Well Name: HENRY AGC FEDERAL	Well Location: T23N / R7W / SEC 29 / NWNW / 36.202824 / -107.604546	County or Parish/State: SANDOVAL / NM
Well Number: 1	Type of Well: OIL WELL	Allottee or Tribe Name:
Lease Number: NMNM36943	Unit or CA Name:	Unit or CA Number:
US Well Number: 300432083200S1	Operator: DUGAN PRODUCTION CORPORATION

Sundry ID: 2805292

Type of Submission: Notice of Intent	Type of Action: Plug and Abandonment
Date Sundry Submitted: 08/06/2024	Time Sundry Submitted: 03:14
Date proposed operation will begin: 08/27/2024

AFMSS 2 Sundry ID 2805292

**Current Wellbore Schematic**

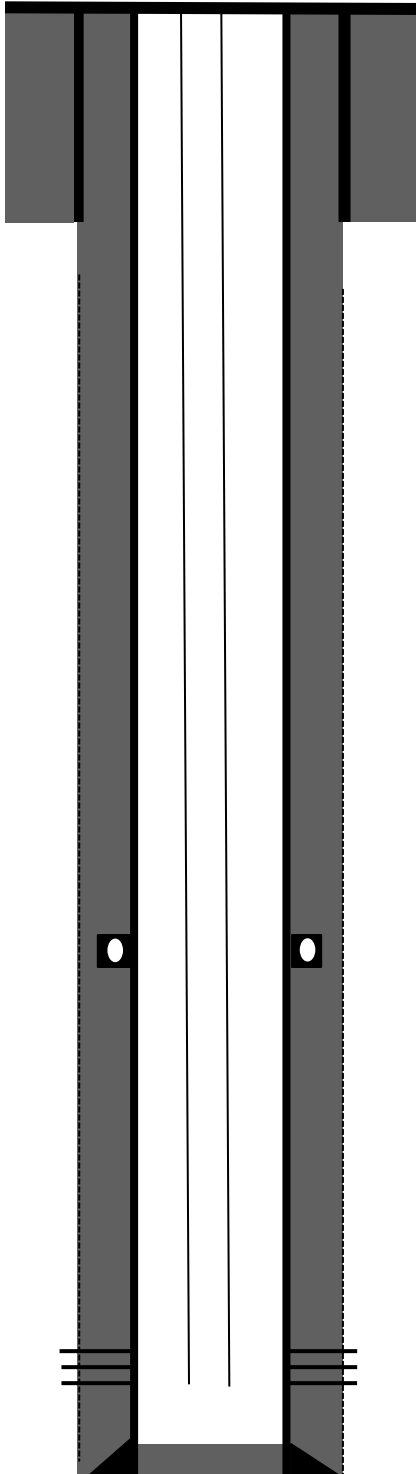
1. Plugging operations authorized are subject to the attached "General Requirements for Permanent Abandonment of Wells on Federal and Indian Lease."
2. The following modifications to your plugging program are to be made:
  - a. Adjust Plug III, or add another plug, to cover BLM formation top selection for the Cliffstone sandstone at 2340 feet.
3. Farmington Office is to be notified at least 24 hours before the plugging operations commence at (505) 564-7750.

Remarks: Adjust plug III to cover BLM-picked top for the Cliffhouse sandstone.
